## NEENAH PLAN COMMISSION

February 7<sup>th</sup>, 2023

**DATE:** February 7, 2023  
**TO:** Mayor Lang and Plan Commission  
**FROM:** Brad Schmidt, AICP, Deputy Director  
**RE:** Site Plan Review – 2001 Marathon Avenue – Multi-Family Residential Conversion

**RE: Site Plan #4-23 - 2001 Marathon Ave - Apartment Conversion\_Garages Site Plan - Major Review () Status  
Conditional**

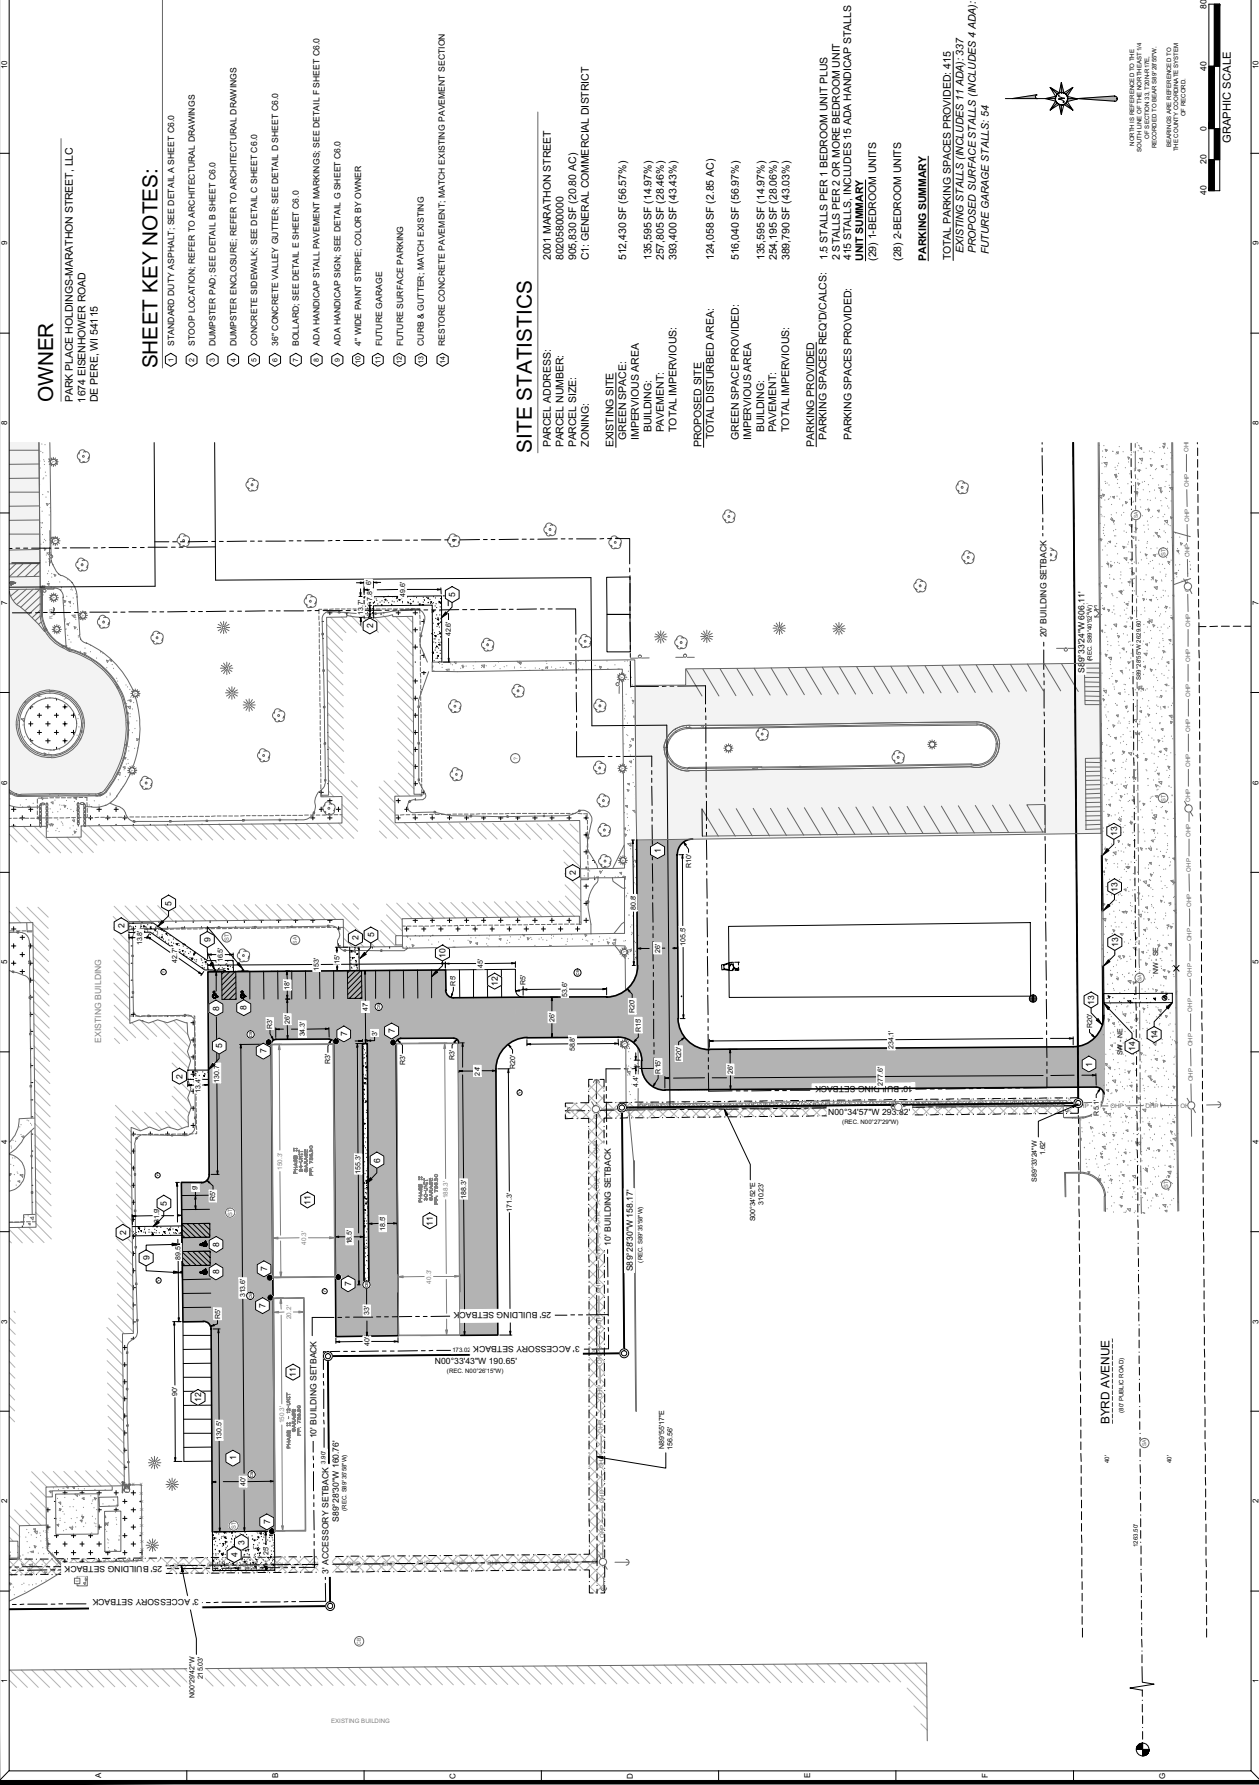
1. Submit a landscape plan showing the location of existing and proposed plantings, type of proposed plantings, and size of proposed plantings.
2. Frontage landscaping - 1 shade tree and 6 shrubs for each 40 linear of feet of frontage (exluding driveway openings) along Byrd Avenu (144 feet) - 4 shade trees and 24 shrubs within the green space along the front property line.

3. Refuse Collection Screening - Submit a detailed drawing of the type of screening around the refuse collection area. A minimum of a 6-foot tall sight-tight fence/wall is required.

4. Interior Landscaping - A minimum of one planting peninsula is required in parking lots for every 12 consectuive parking stalls. Each peninsula is required to be 180 square feet and include one shade tree. This only applies to the proposed parking near the detached garages on the south portion of the property.

5. Multi-Family Development plantings - A minimum of 0.2 canopy trees per unit (12 canopy trees), 0.4 ornamental trees per unit (24 ornamental trees) and 1.5 shrubs per unit (87 shurbs) are required. Existing plantings and trees can count towards this requirement.

6. Please remove the existing asphalt on the parking lot east of the proposed storm water pond creating a 10-foot wide frontage landscape strip along Byrd Avenue. The area from the curb to the front property line and an additional 10 feet north of teh front property line shall be maintained as grass.

(1) Reconstructed driveway aprons should be designed and constructed to include 5' ADA-compliant sidewalk along the right-of-way line. This only affects the westerly Byrd Avenue driveway per the current plan.

Development site should account for pedestrian access to the street network, not just vehicle access. The current plans show the existing sidewalk that extends from the building to Marathon Avenue, which appears to remain in place. However, the existing sidewalk shown on page C1.1 along the east side of the south parking lot (connecting the building to Byrd Avenue), does not exist in the rest of the plans. Is this an error or intent to remove the sidewalk?

13. The north most drive shall be required to provide a turnaround at the end of the driveway.
  - a. The turnaround must meet the requirements set forth in the 2021 IFC, Appendix D, Section D103.
